## AMENDED Service Provider Letter

Jurisdiction:	<u>City of Tualatin</u>	Review Type:	<u>Tier 2 Analysis</u>
Site Address	<u>19000 SW 124th Ave</u>	SPL Original Date:	<u>January 31, 2023</u>
/ Location:	<u>Tualatin, OR 97062</u>	SPL Amendment Date:	<u>September 14, 2025</u>
		SPL Expiration Date:	<u>September 14, 2027</u>

**FIRE CODE / LAND USE / BUILDING REVIEW  
APPLICATION**

**TVF&R Permit #2026-0004**

**FIRE SERVICE PLAN**

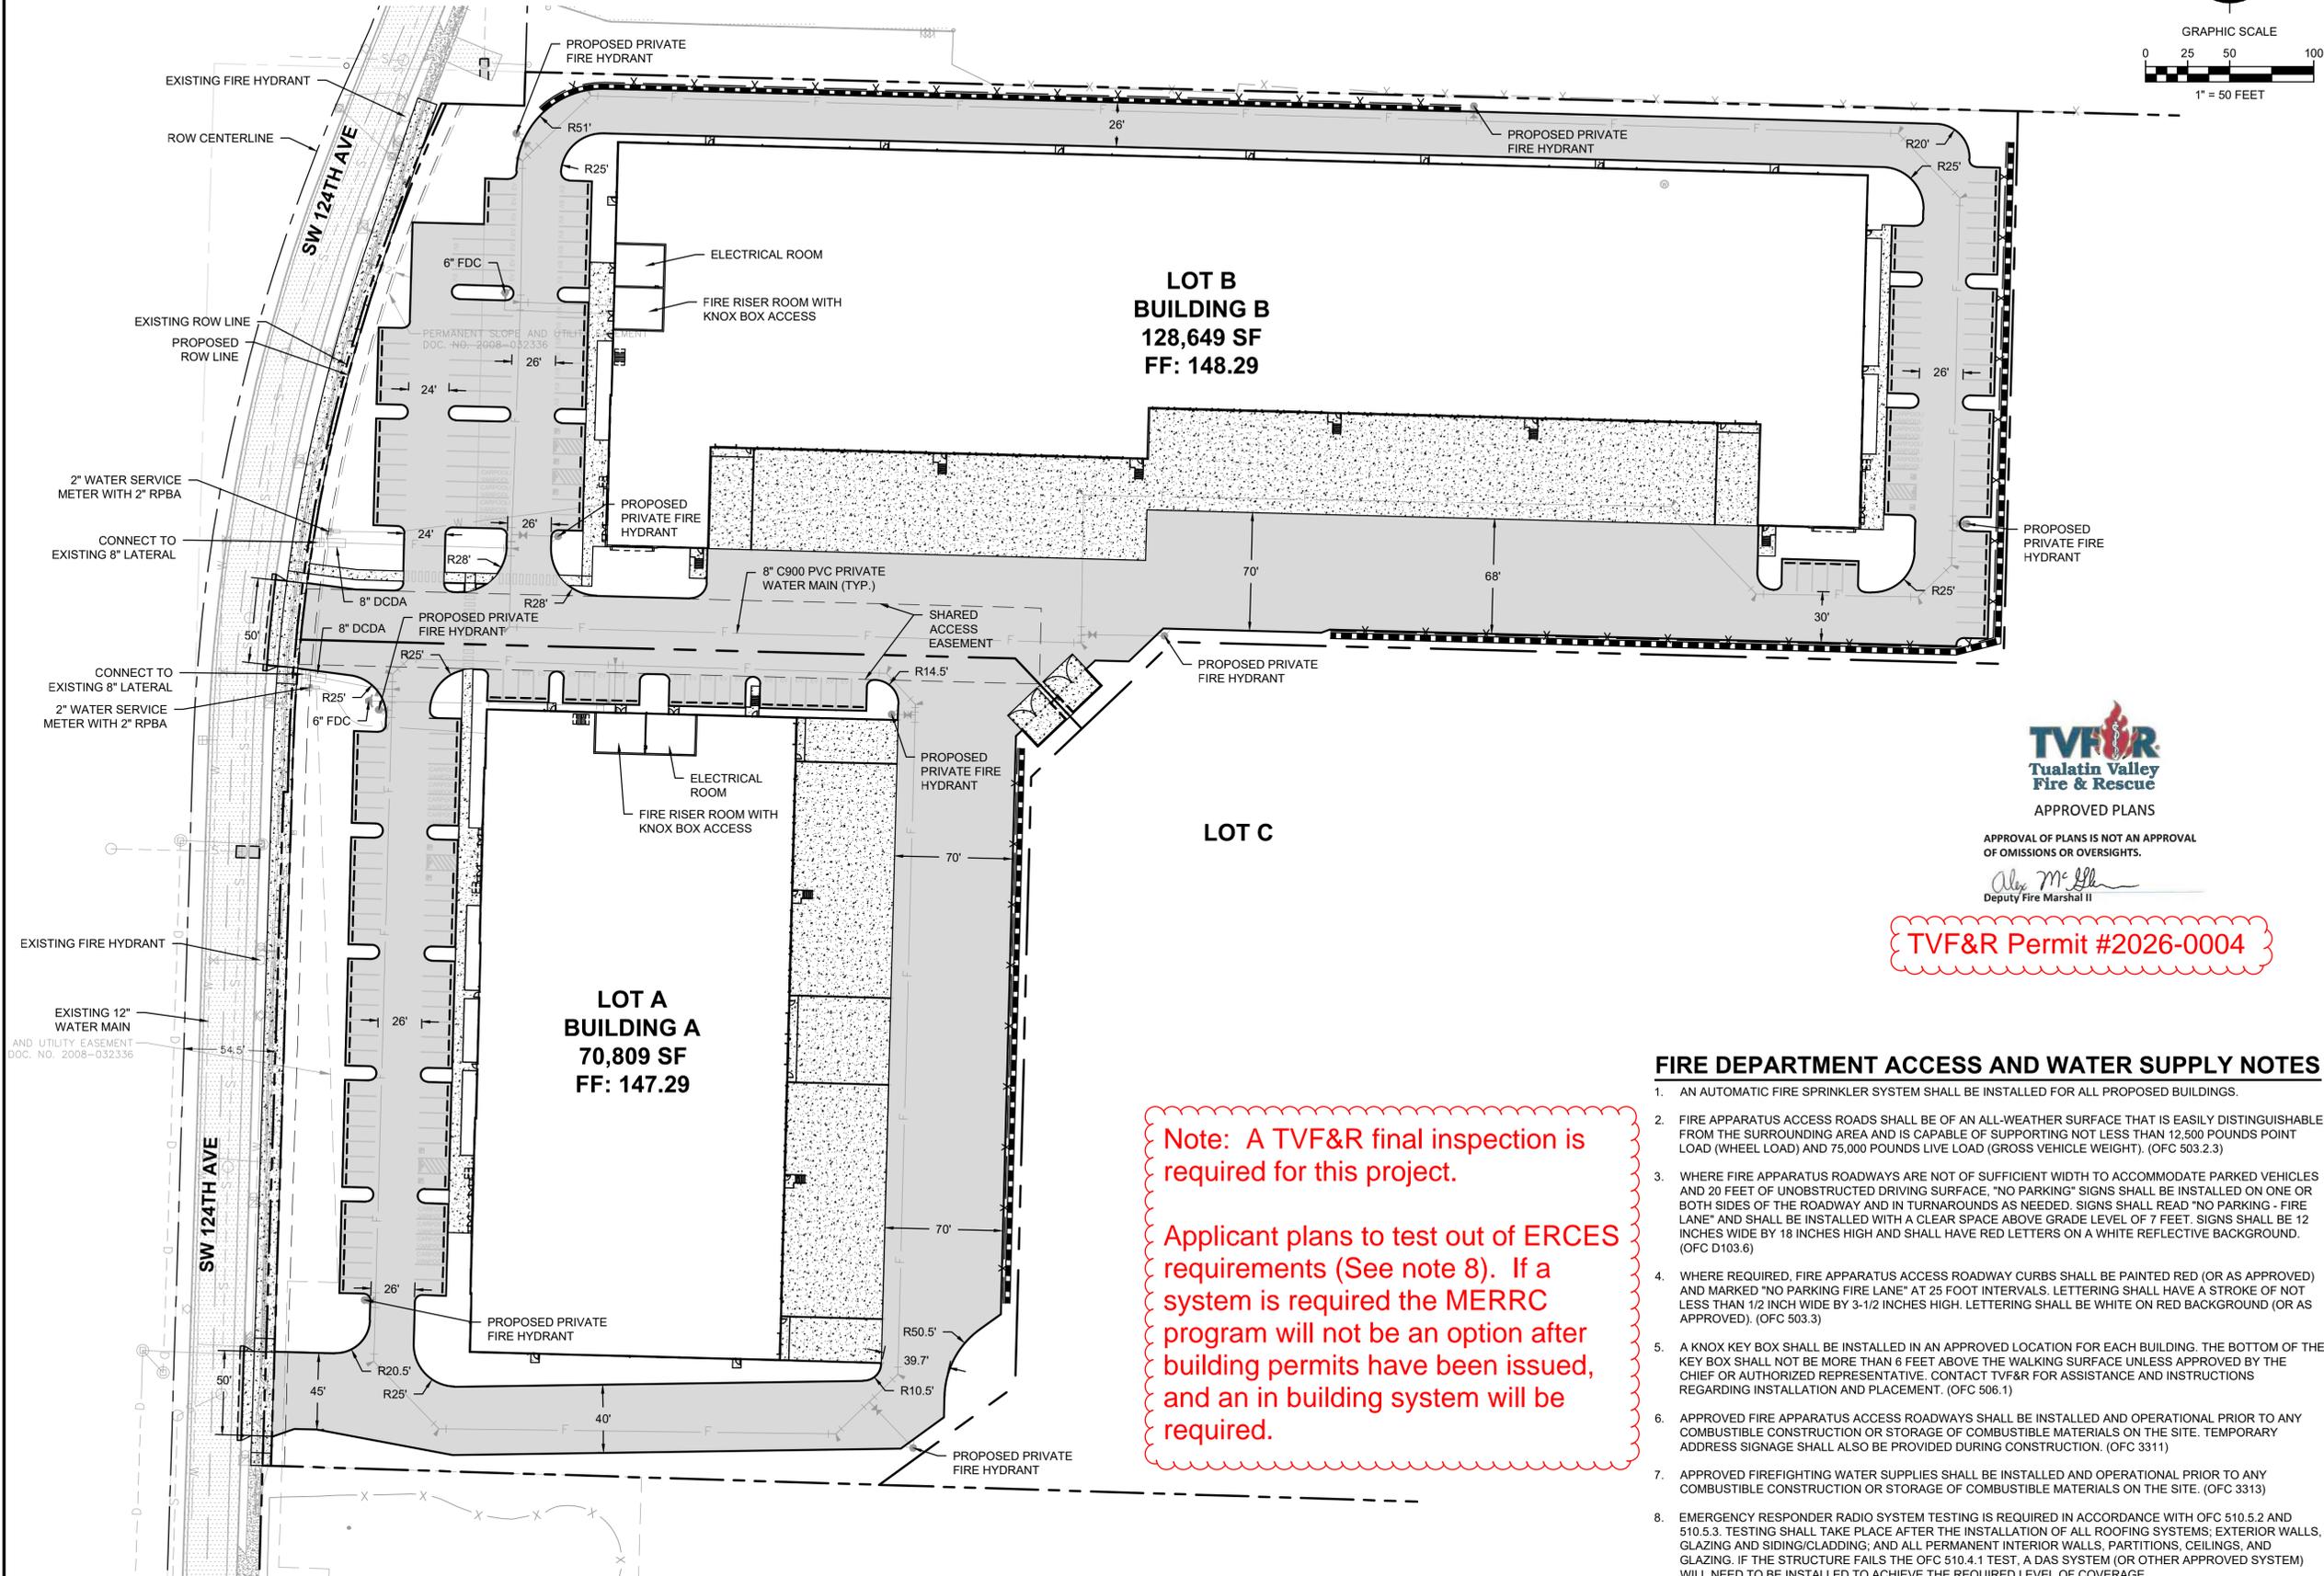
Note: A TVF&R final inspection is required for this project.

Applicant plans to test out of ERCES requirements (See note 8). If a system is required the MERRC program will not be an option after building permits have been issued, and an in building system will be required.

8. EMERGENCY RESPONDER RADIO SYSTEM TESTING IS REQUIRED IN ACCORDANCE WITH OFC 510.5.2 AND 510.5.3. TESTING SHALL TAKE PLACE AFTER THE INSTALLATION OF ALL ROOFING SYSTEMS, EXTERIOR WALLS, GLAZING AND SIDING/GLADDING; AND ALL PERMANENT INTERIOR WALLS, PARTITIONS, CEILINGS, AND GLAZING. IF THE STRUCTURE FAILS THE OFC 510.4.1 TEST, A DAS SYSTEM (OR OTHER APPROVED SYSTEM) WILL NEED TO BE INSTALLED TO ACHIEVE THE REQUIRED LEVEL OF COVERAGE.
